# SS 583339 FCCC 2012-2024 MT45G & MT55G 6.0-Liter Gas or CNG Failed/Cracked Fuel Pump Fuse (303)

FCCC 2012 2024 MT45G or MT55G 6.0 Liter Engines

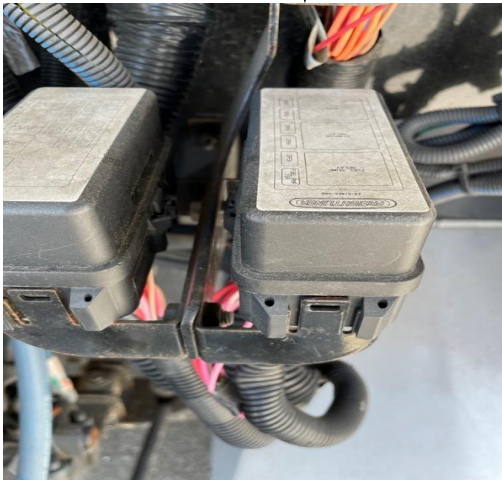
Step 1: Open the hood, and locate the PDM with the fuel pump fuse (pointed at in the picture below)

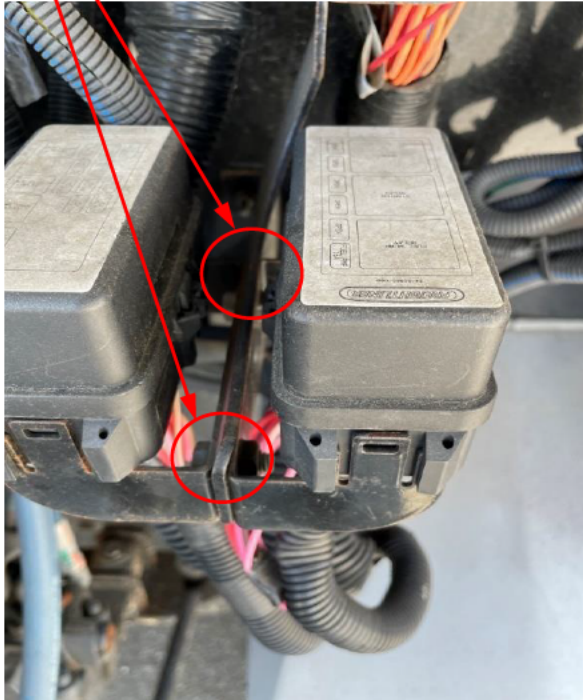
The PDM is the one on the right

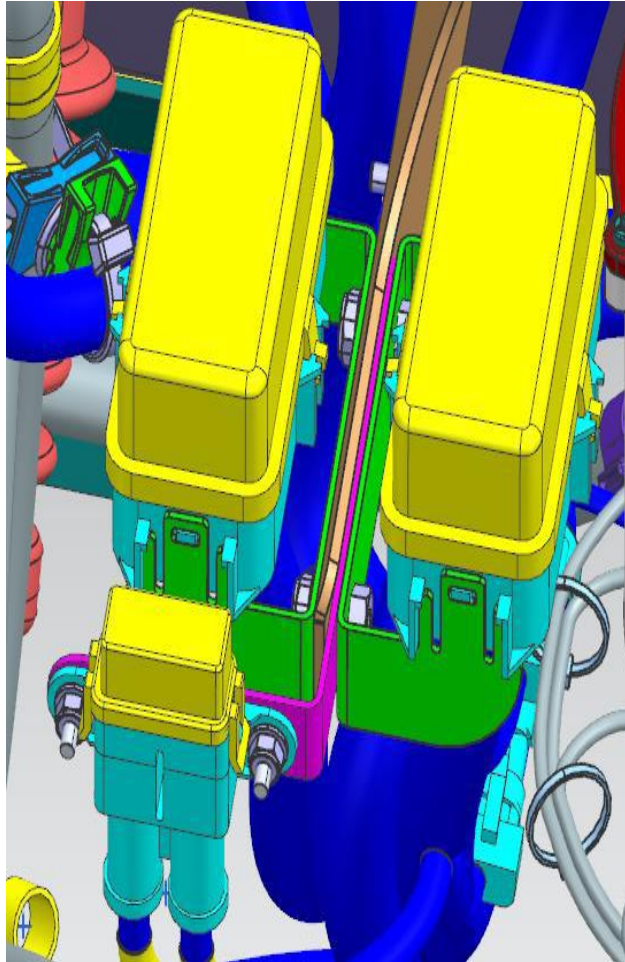
Step 2: Remove screws(2) identified below:

Isometric view

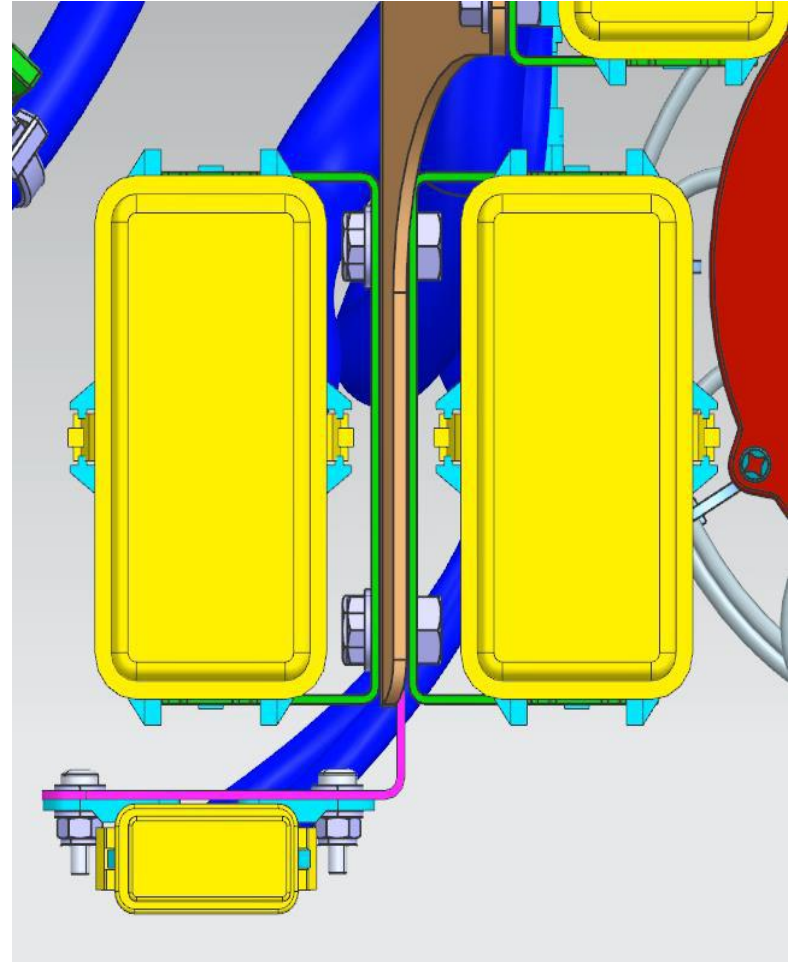
Step 3: Install the Maxi fuse bracket with the fuse holder as shown below (longer screws may be needed):
